Product Change Notice

Introduce Alternate Lead Frame Source

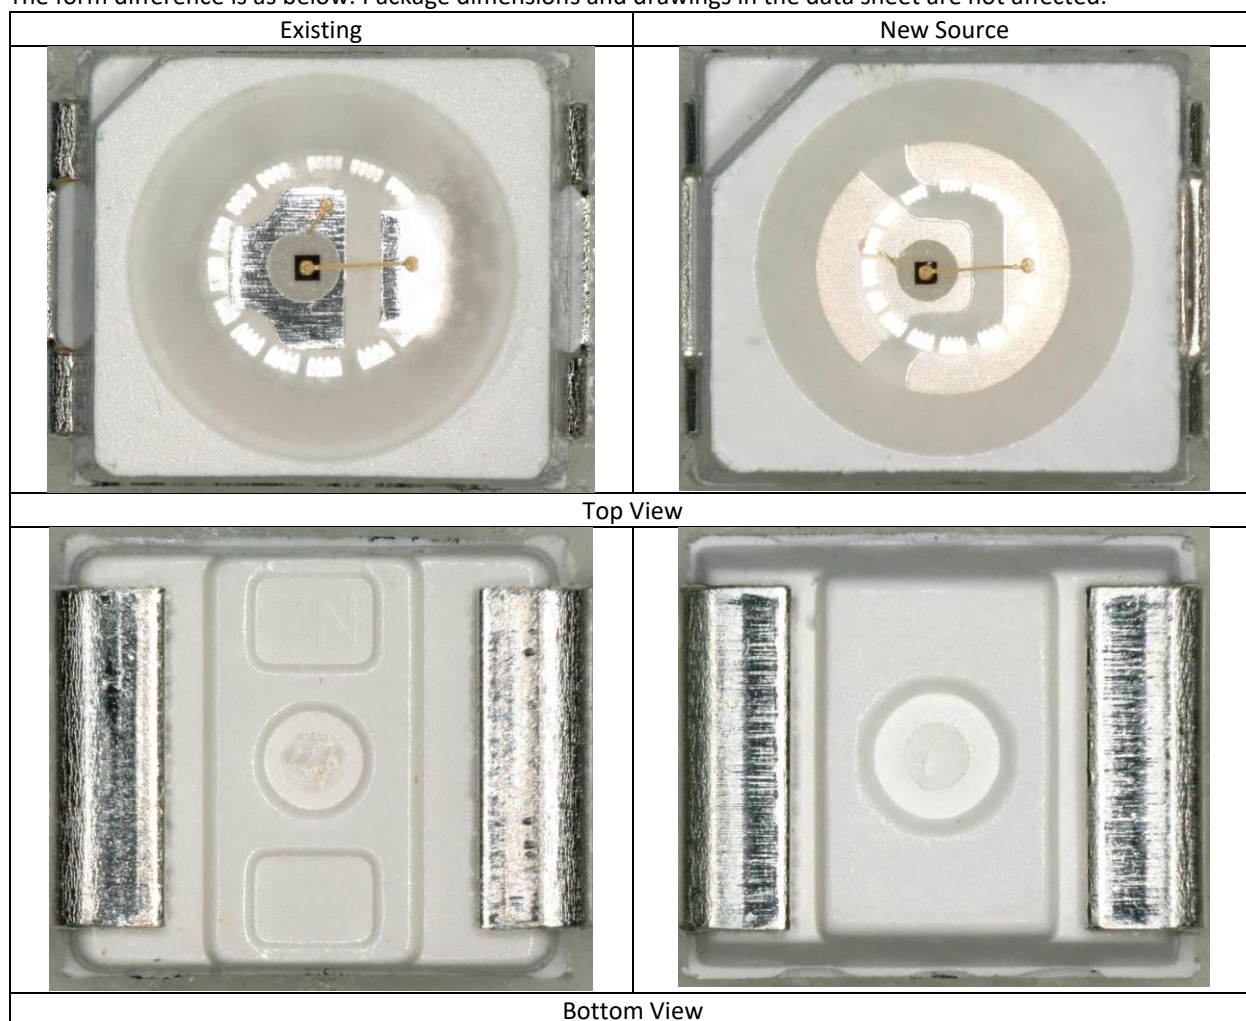
To introduce alternate lead frame source for the part numbers listed above.

The form difference is as below. Package dimensions and drawings in the data sheet are not affected.
